MCPB
Item # 7
4/08/10

MEMORANDUM

SUBJECT: Mandatory Referral No. 09736-MCPS-1: Seven Locks Elementary School
School Replacement Facility Project
9500 Seven Locks Road, Bethesda, R-200 Zone, Potomac Subregion Master Plan

RECOMMENDATION: Approval to transmit the following comments to Montgomery County Public Schools (MCPS):

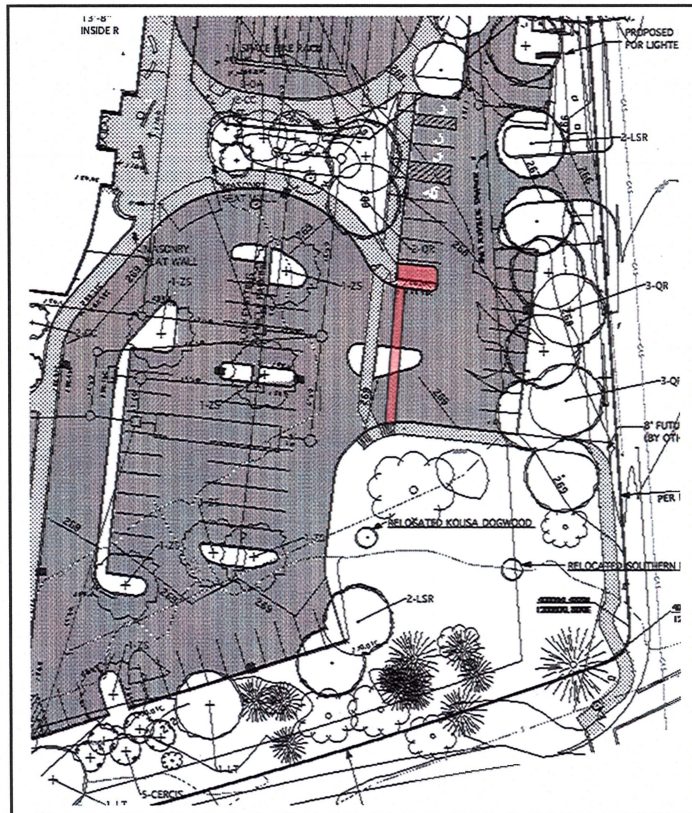
Landscape and Lighting: The submitted Landscape Plan proposes tree save throughout the site; the Landscape Plan should be revised to include the following:

- a. Provide striped cross walks across all curb cuts along the Seven Locks Road frontage. Dimension according to the future specifications for the shared-use path; provide signage for the main pedestrian site entries;
- b. To enhance student pedestrian safety, eliminate the pedestrian walk that adjoins the retaining wall and ends at the loading dock, along the north property boundary;
- c. Four more shade trees along Seven Locks Road and five more along Bradley Boulevard;
- d. Ornamental trees and foundation plantings at the storage area front façade;
- e. Provide two clusters of three shade trees near the Kindergarten play areas;
- f. Shade trees should be a large leaf species such as a red oak and a size of 2.5-3.0 inch caliper at the time of planting.

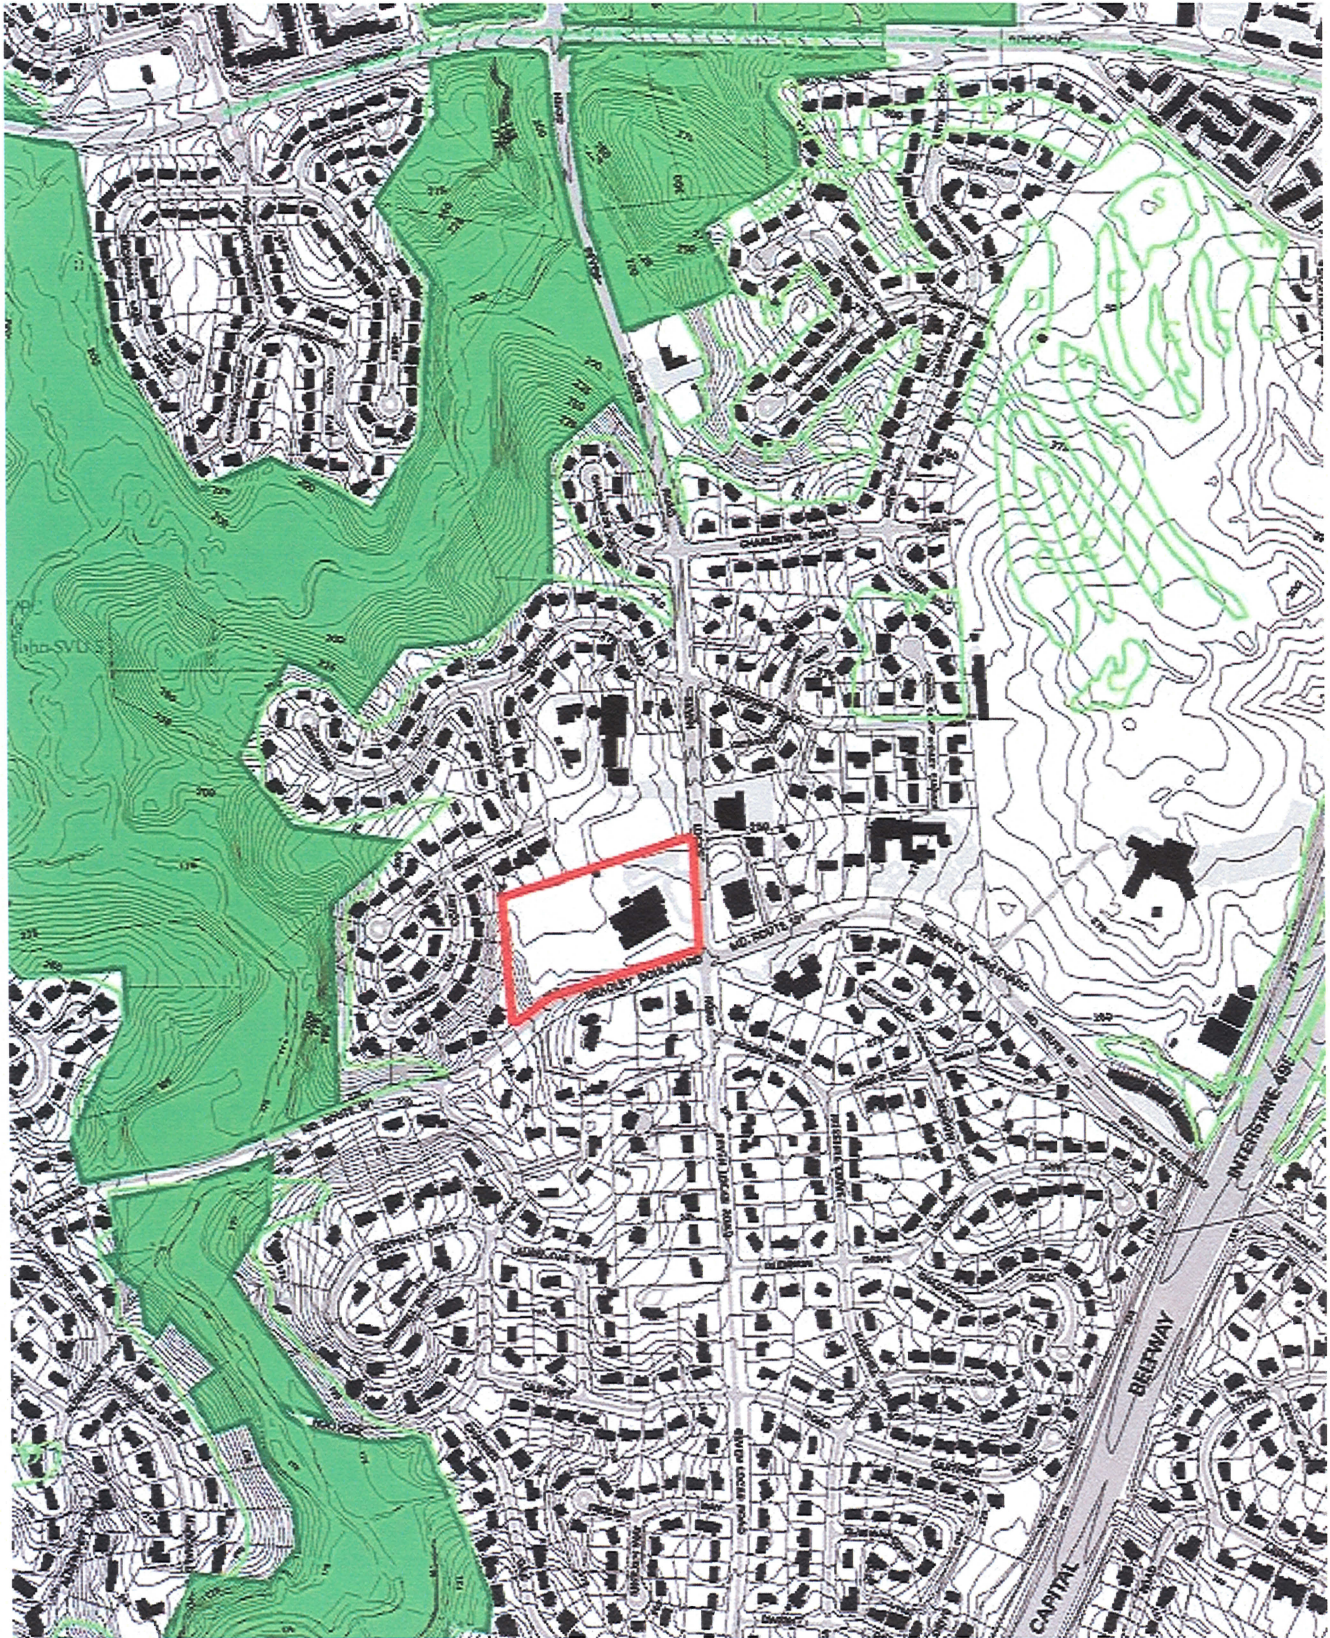
- b. Investigate the use of native plants as landscaping and minimize use of non-natives.
4. Pedestrian Safety
 - a. Provide the following revision to the landscape/pedestrian circulation plan to achieve adequate pedestrian safety: Shift parking spaces northward, or eliminate one parking space to allow the straight alignment of the pedestrian (student) crosswalk, with a shorter, more direct path through the surface parking area. [See Illustration below, page 13.]

Pedestrian access from Seven Locks Road is provided via lead sidewalks that follow the form of each of the major traffic island: one from the north side along the edge of the bus circulation and the other, an angled path that crosses the parent drop-off/pickup vehicular circulation. Both sidewalks direct pedestrian traffic to the centralized plaza that frames the building portico. To enhance pedestrian safety, staff recommends that the south sidewalk crossing the parent drop off/parking be offset eastward about 8-10 feet to create a straightened path, augmented by a larger refuge island. This minor adjustment will increase the visibility of pedestrians, both to drivers and other pedestrians. [See illustration below.]

Shared Use Bicycle and Pedestrian Path: Staff recommends that MCPS coordinate with MCDT on the design, planning and construction of the proposed path along the Seven Locks Road frontage. It is critical that an interim pedestrian path be provided for neighborhood children and adults if the path installation is delayed beyond the completion of the replacement school facility. Staff further recommends the provision of a decorative fence to separate the head-in parking spaces and their occupants from moving bicycles and pedestrians. It should be noted that 3 full parking spaces and a portion of six other spaces are located within the zoning setback line. The decorative fence recommended above, should be so designed to screen the visual effect of the parking from the street. [See Illustration above.]

Seven Locks Elementary School Attachment #4: Landscape Plan

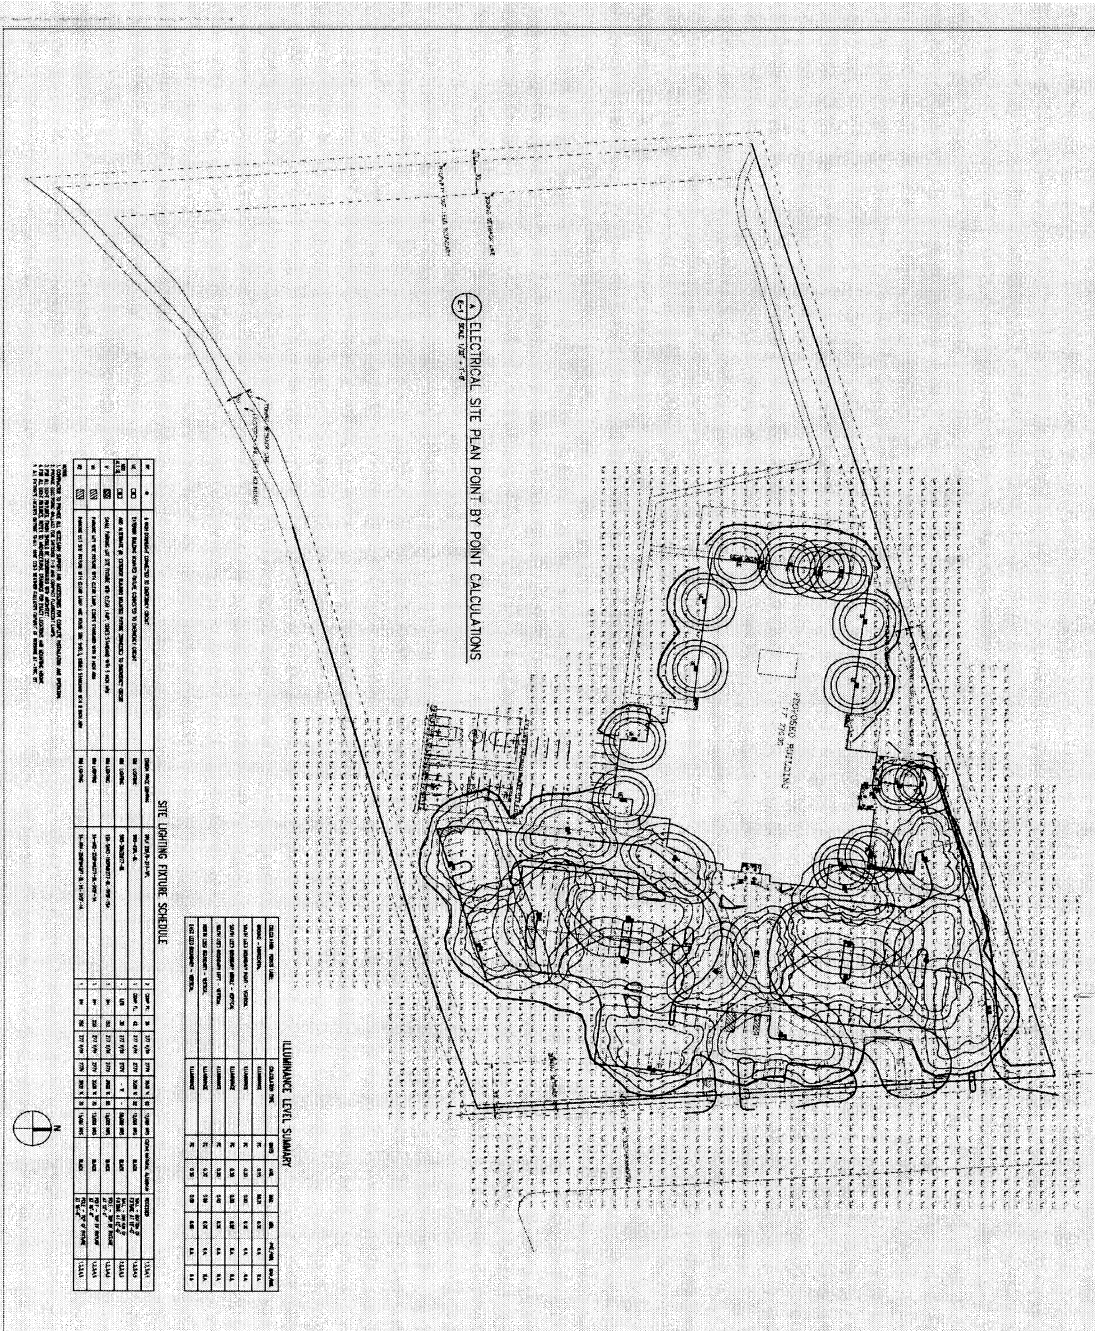
- a. Four additional shade trees along the Seven Locks Road frontage; five shade trees along the Bradley Boulevard frontage; three additional ornamental trees and foundation plantings to screen the front of the storage area façade;
